SAFETY RECALL

Date	Number	Release	Page
07.2019	RVXX1904	01	1(5)

Air Tank Strap, Inspection VNL, VAH

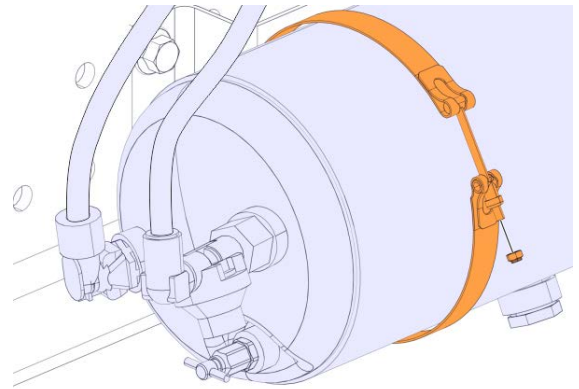
6. Remove the strap.
7. Remove the nut.

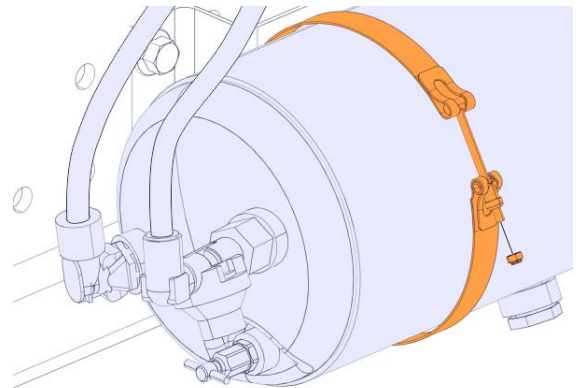
8. Install the strap.
9. Install the nut.
10. Torque tighten the nut.

Tightening torque	
1/4-28 t-bolt clamp nut	12 ±1.5 Nm (9 ±1 lbf ft)
